Architectural Commission Report

Meeting Date: Wednesday, August 20, 2014

Subject: **AMERICAN TEA ROOM (PL1412316)**
401 North Canon Drive

Request for approval of a façade remodel, business identification signage, and outdoor dining elements. The Commission will also consider adoption of a Categorical Exemption, pursuant to the California Environmental Quality Act.

American Tea Room CANON DRIVE ELEVATION
 401 North Canon Drive
 Beverly Hills, CA 90210

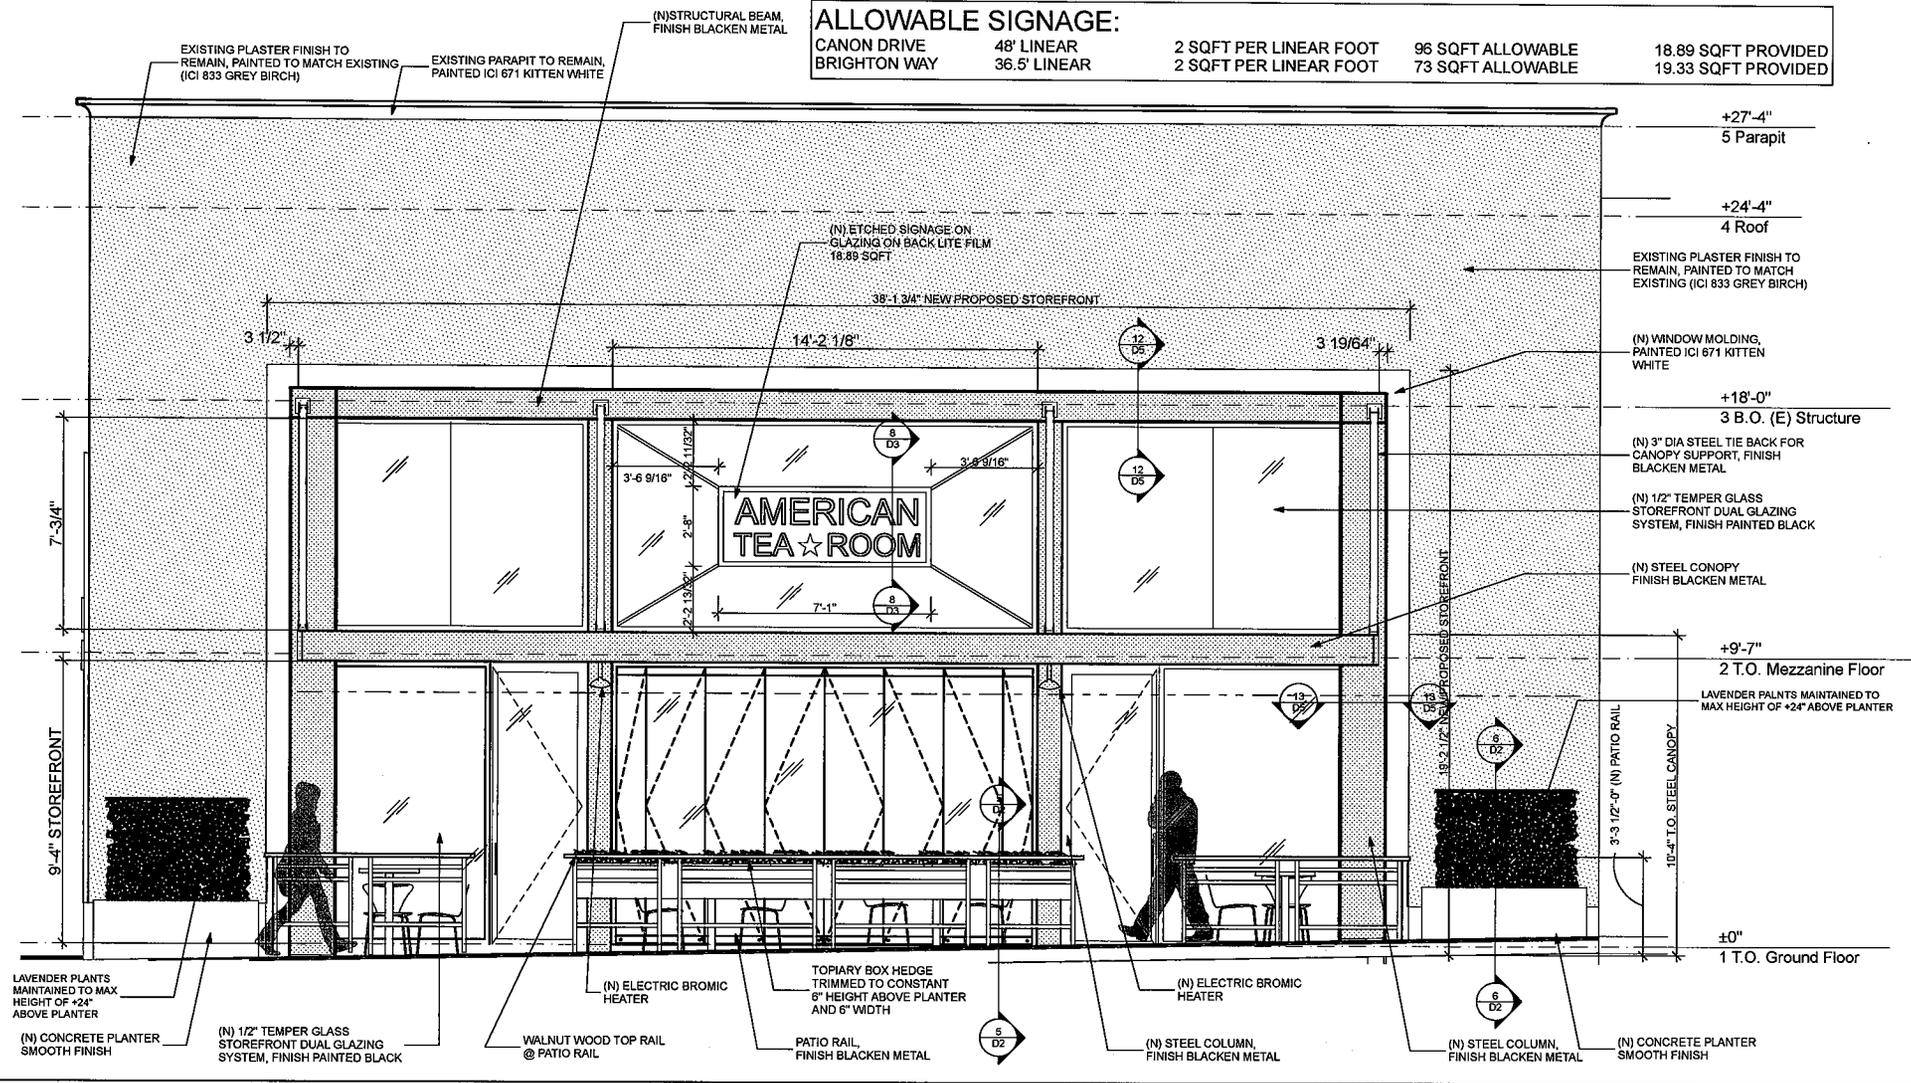
Note: As of the printing of this report, staff has not been able to confirm that the removable planters and steel canopy are permissible encroachments into the public right-of-way.

Pursuant to Beverly Hills Municipal Code (BHMC) §10-4-604, the maximum sign area for a ground floor business with street frontage is calculated at a ratio of 2 SF for each one foot of linear street frontage (2:1 ratio). Based on a street frontage of approximately 48'-0", the maximum sign area for this tenant is 96 SF.

The proposed project is tasteful in its aesthetic and will positively enhance the streetscape of North Canon Drive. Additionally, the façade remodel will greatly contribute to the street wall as the new design increases transparency between the interior of the store and the street.

American Tea Room BRIGHTON WAY ELEVATION
 401 North Canon Drive
 Beverly Hills, CA 90210

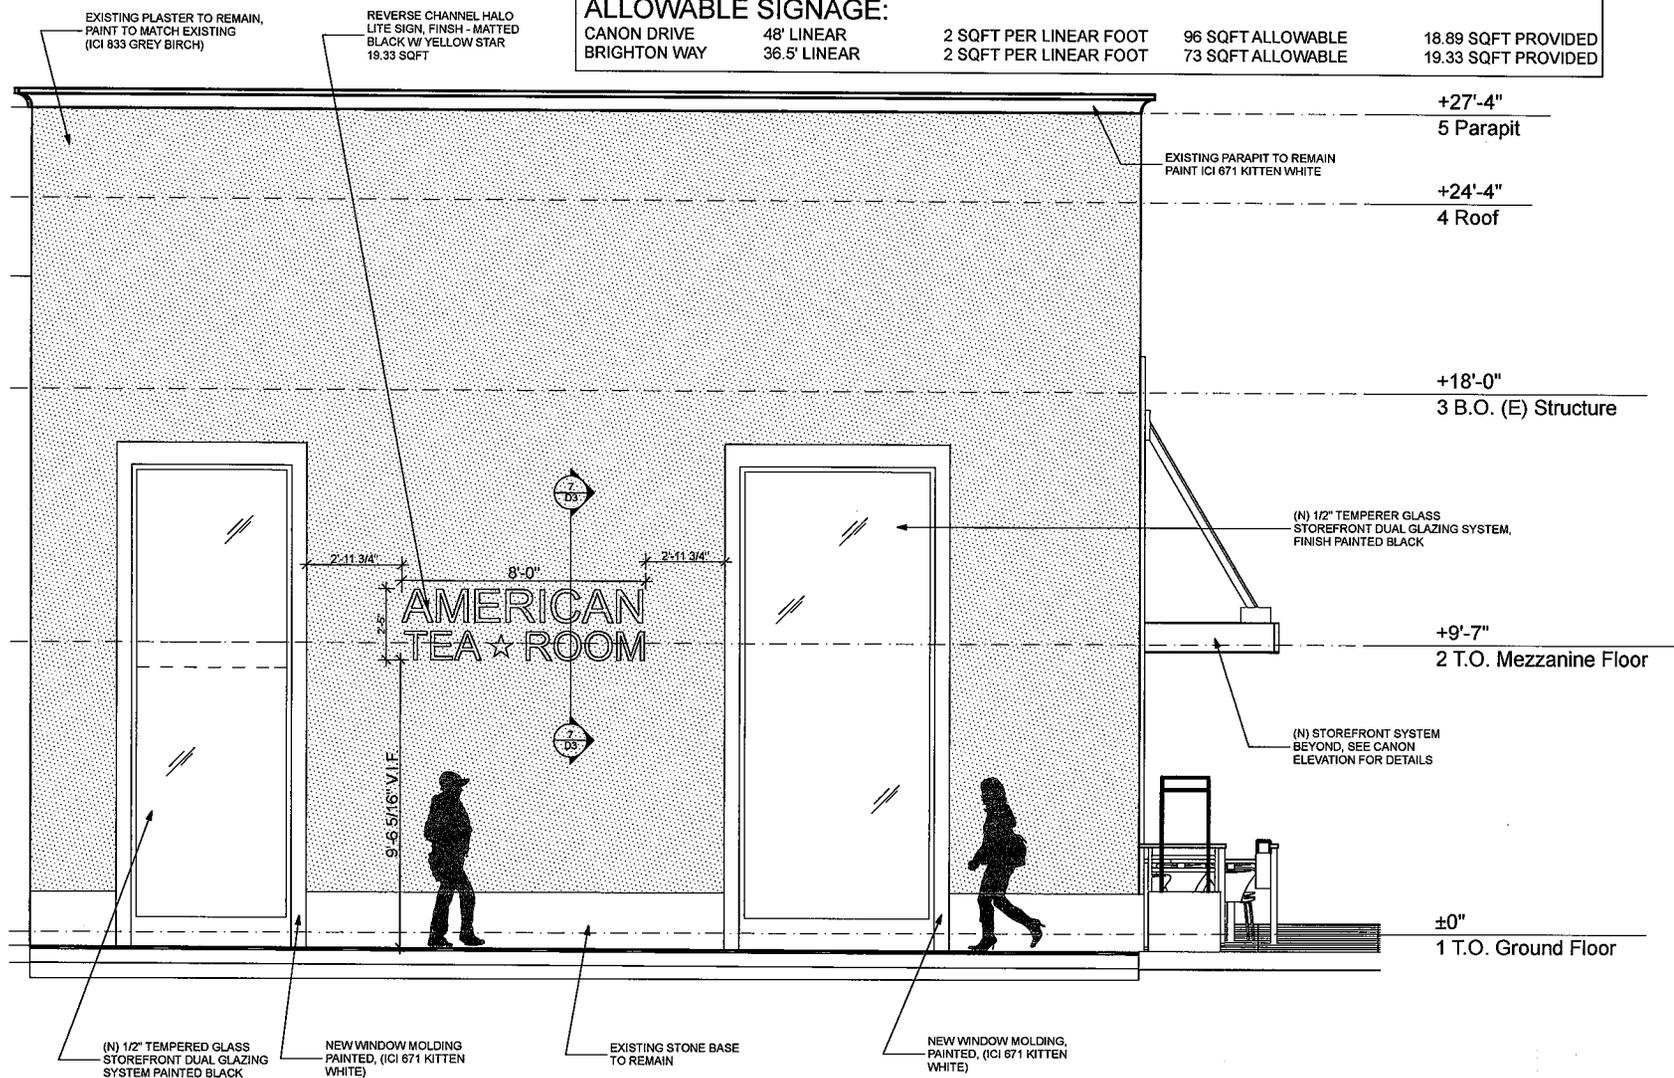
Pursuant to BHMC §10-4-604, a ground floor business with street frontage may also have a business identification sign located on a street face of the building other than the face that contains the main entrance of the business (i.e., a corner property). The maximum sign area for this elevation is calculated at the 2:1 ratio; however, the maximum sign area is 30 SF.
